CS Memorandum No. 1328

Subject: Configuration Management Board Meeting No. 107

CMB Meeting Minutes #107

SUBJECT: Configuration Management Board Meeting # 107 – Rev. No. 0

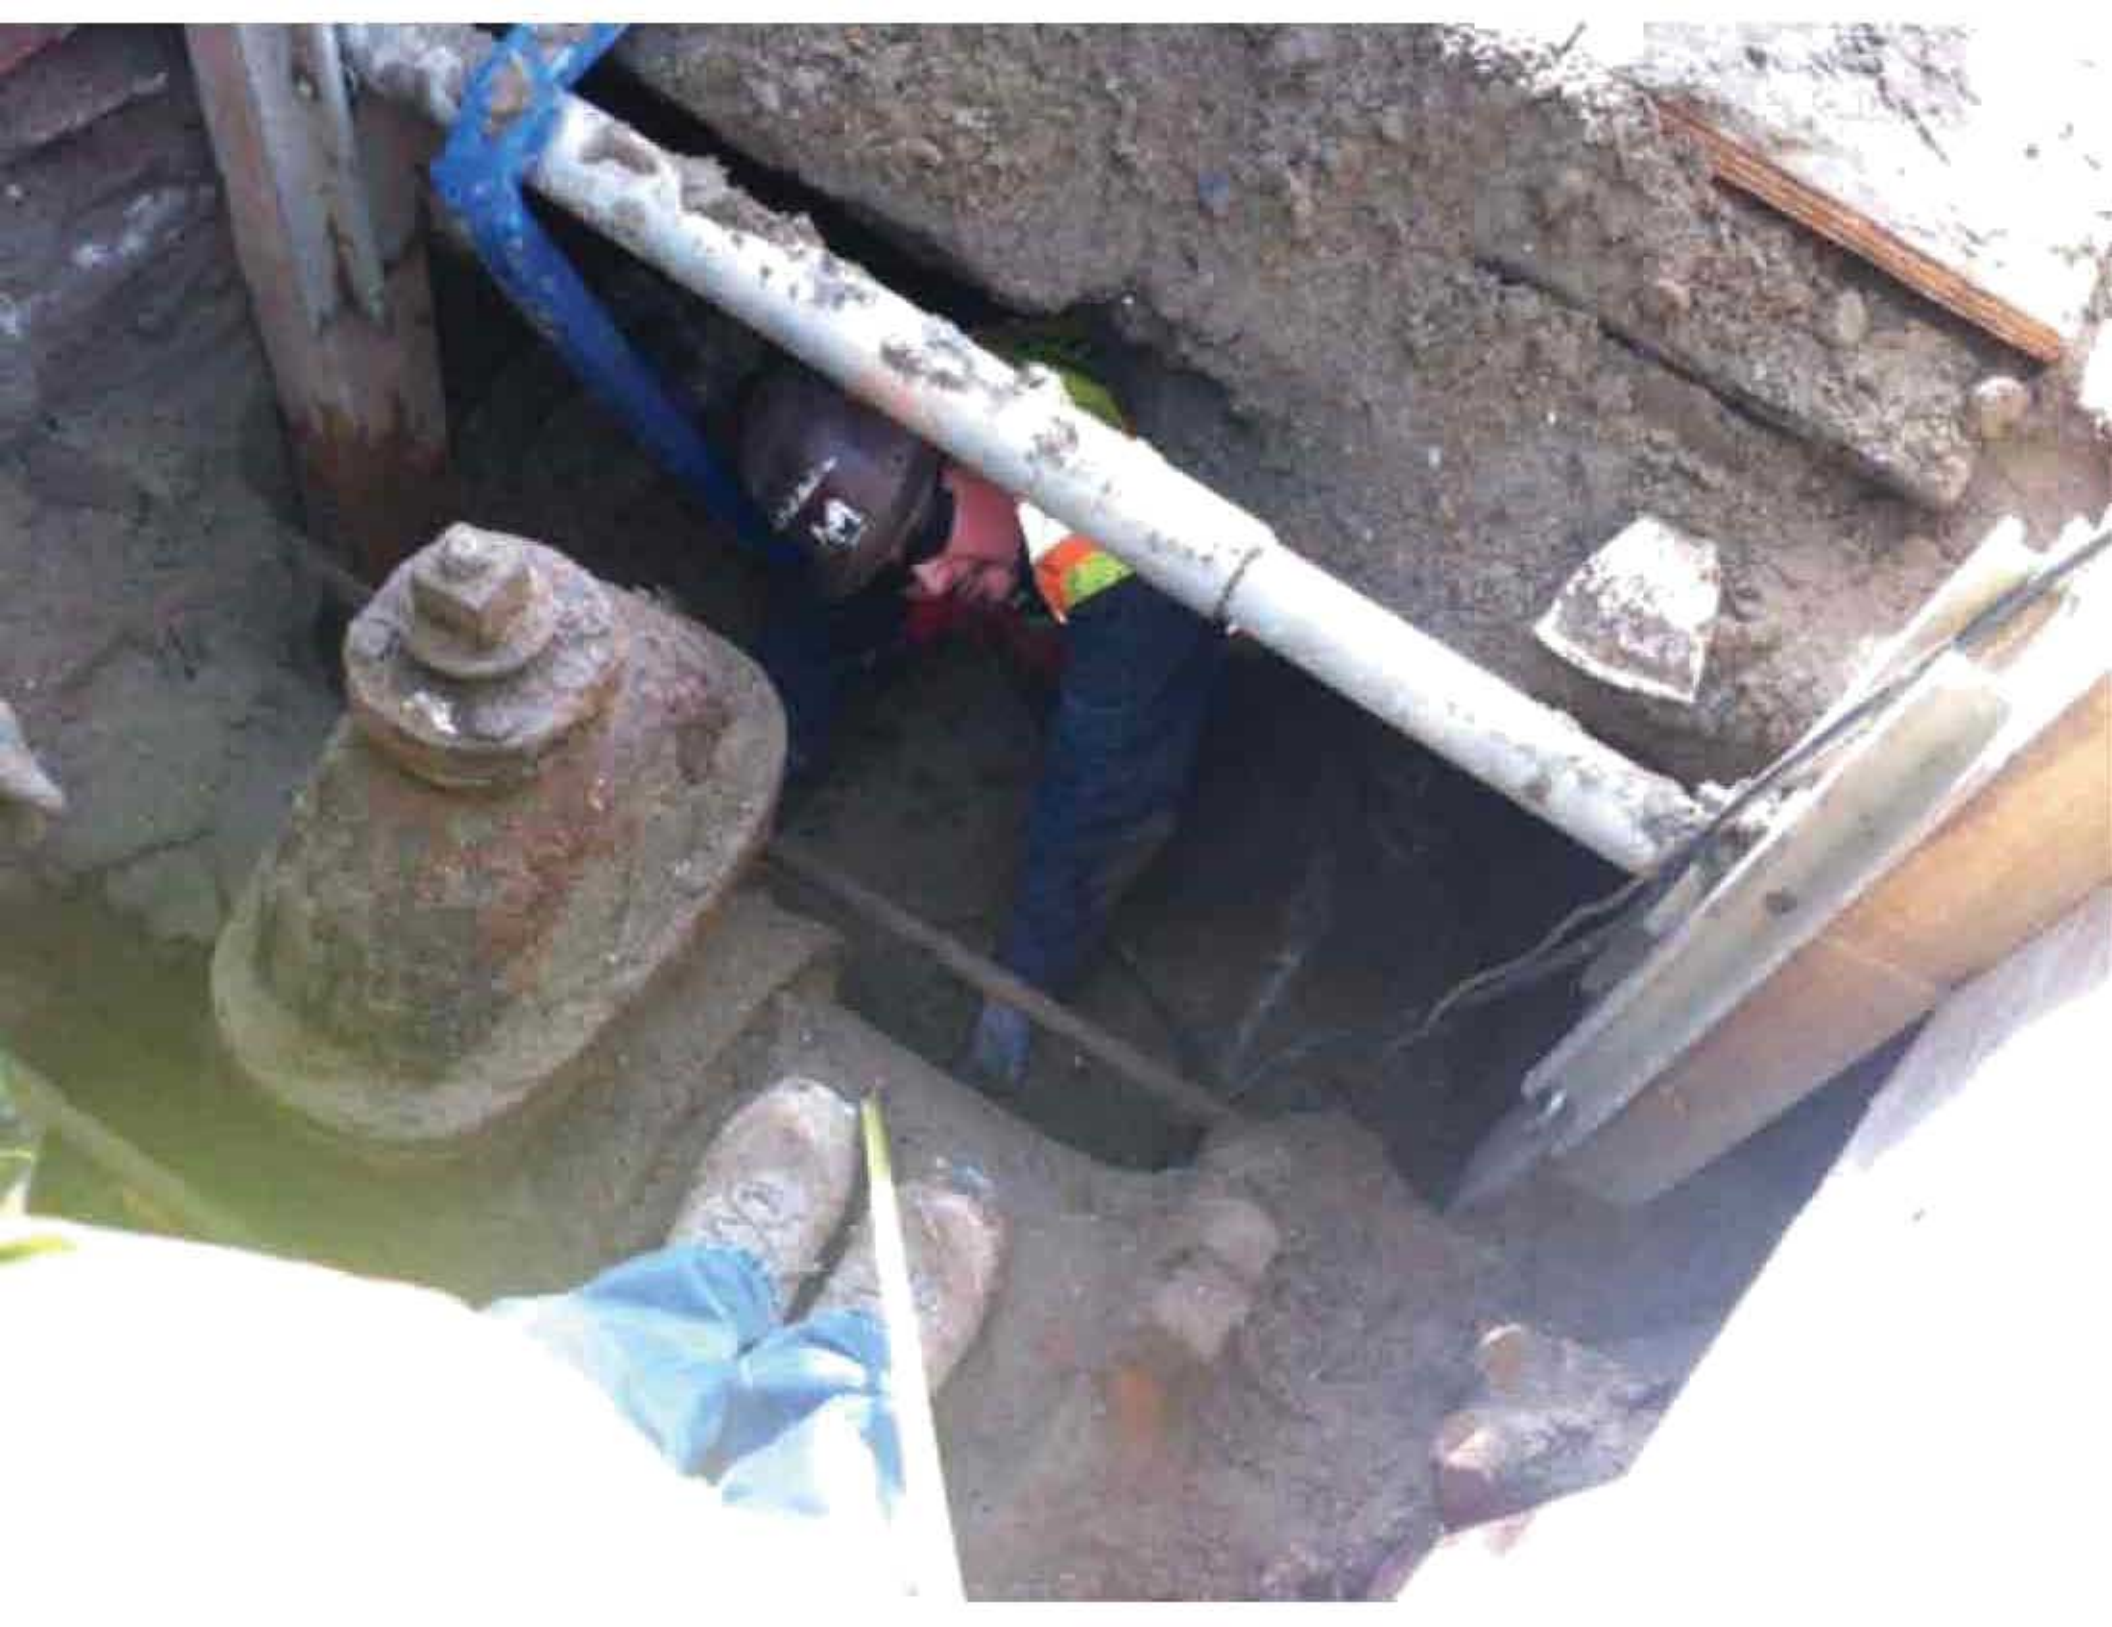
It was discovered that the existing AWSS "T" fitting shown on contract drawing AW-501.12 is in conflict with an existing 12" water line. The water line, which is shown to be located 3 feet away on contract drawing UT-501 is actually only 2-3 inches away and does not provide adequate space needed for the tie-in work to the existing AWSS "T" fitting required by drawing AW-501.12. Synergy is not physically capable of gaining access to the tie rod bolts required to tighten the mechanical joint fittings at this location. Synergy's workers have already had to undermine the existing 12" water utility just to examine the utility conflict and can't continue the installation of new AWSS fittings. Synergy has removed the existing lead joint pipe and recommends leaving the ductile iron pipe intact and installing new tie rods between the new 90 degree elbow and the existing "T" fitting. Also, the existing thrust block was poured in such a way that it is covering a portion of the existing "T" fitting and will need to be chipped away in order to install the new tie rods. Can the SFMTA direct us how to proceed?

Rationale for COR: SFMTA issued a response to RFI 56 directing the Contractor to restrain the AWSS pipe. The RFI response prepared by Michael Smith of the San Francisco Department of Public Works stated: "Added 04/18/12: Following confirmation after SFDPW field inspection of exposed AWSS line, restrain the existing 12-inch tee to the existing pipe north of the tee. Restrain any other joints that are not restrained on the existing pipe up to the new pipe to be installed." Additional details of the connections were then provided by SFMTA for Contractor to execute the work.

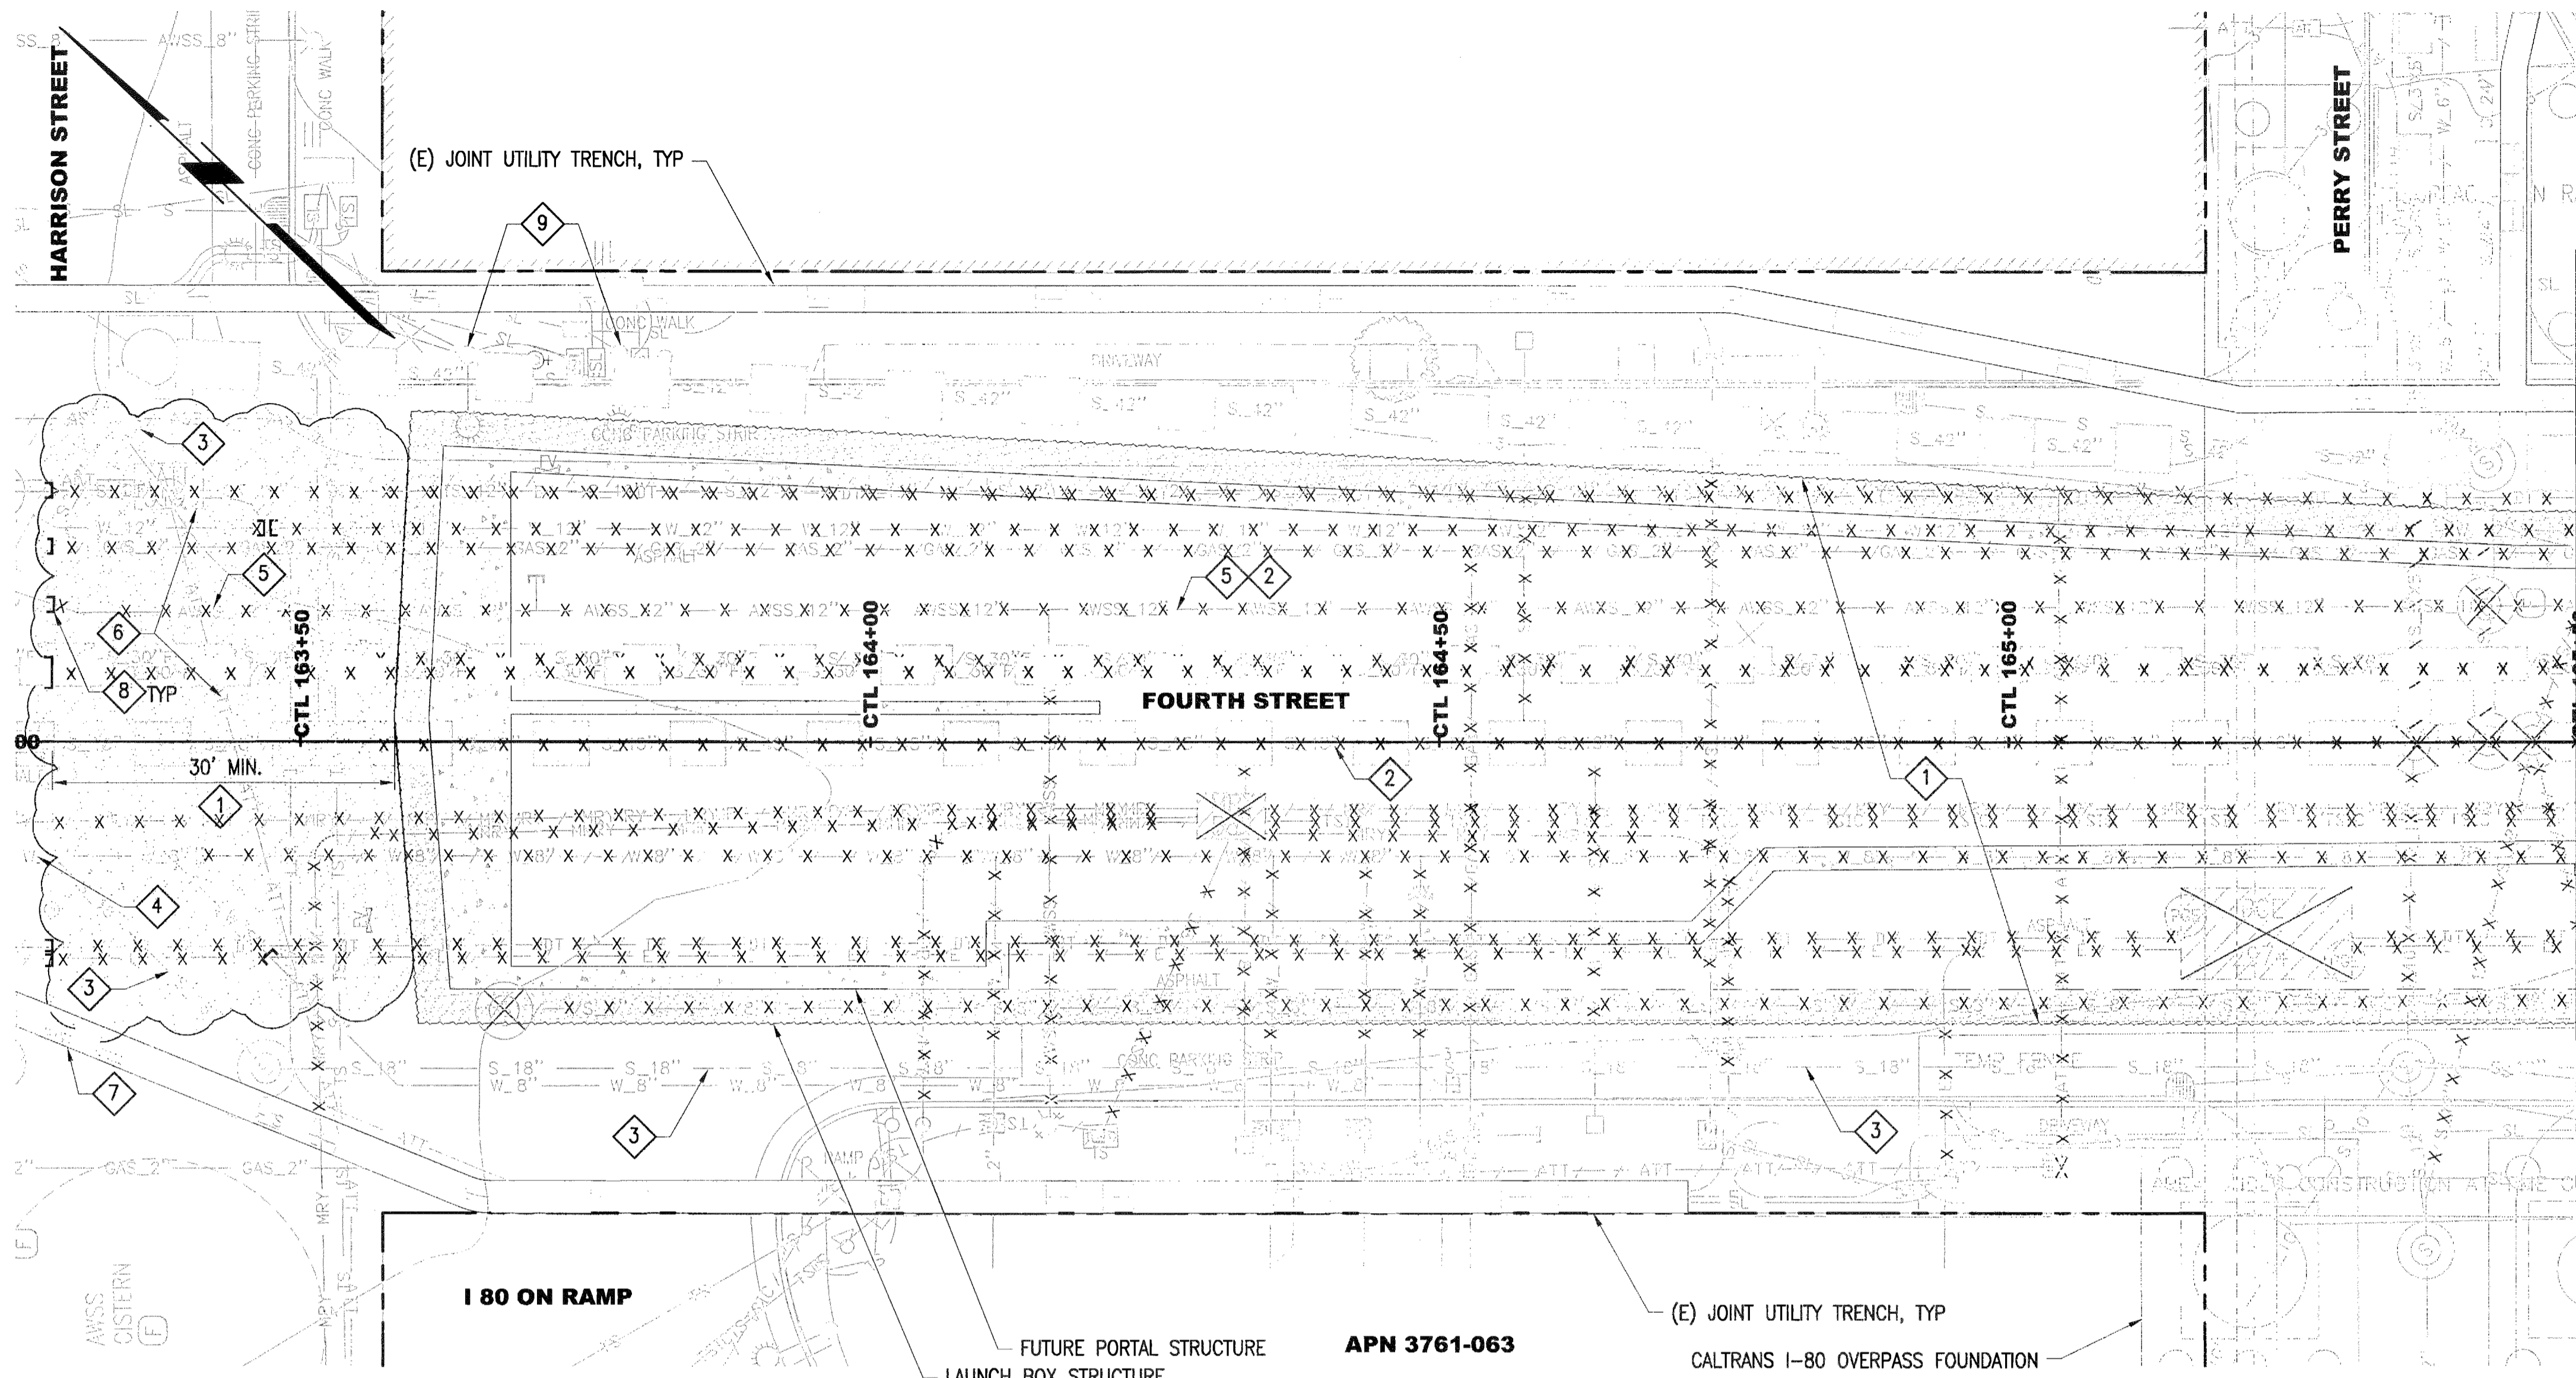
Facts: During construction of the slurry wall for the west wall of the tunnel launch box, BIH subcontractor, Condon Johnson – Nicholson Construction Company Joint Venture (CJA-NCC), uncovered an existing 8" vitrified clay pipe (VCP) sewer main encased in concrete. The concrete encasement was found by the Contractor to extend to a depth of 9'-11' below the top of guide wall or street surface. The 8" VCP sewer main and concrete encasement was incorrectly shown in the contract drawings to be approximately 4'-5' below the street surface.

Rationale for COR: The sewer line encased in concrete was a differing site condition. Additional costs were incurred to remove the concrete and place additional slurry (bentonite and water) to fill the resulting over-excavated wall width due to the concrete encasement removal.

Justification: The contract documents show that the concrete encased sewer pipe was at a depth shallower than was found at the Site. For the condition shown in the contract documents, the VCP sewer line could have been broken and removed along with the soil excavation during the Contractor's guide wall construction. Additional equipment and labor were required to remove the concrete and to fill the resulting over-excavated wall width with additional slurry. The work was required to be completed before the Contractor's slurry wall production could continue.

Recommendation: Accept justification of Merit for COR 015, for pre-excavation to remove concrete encased sewer line at the west slurry wall of the tunnel launch box. Time impact associated with this COR has not yet been determined.
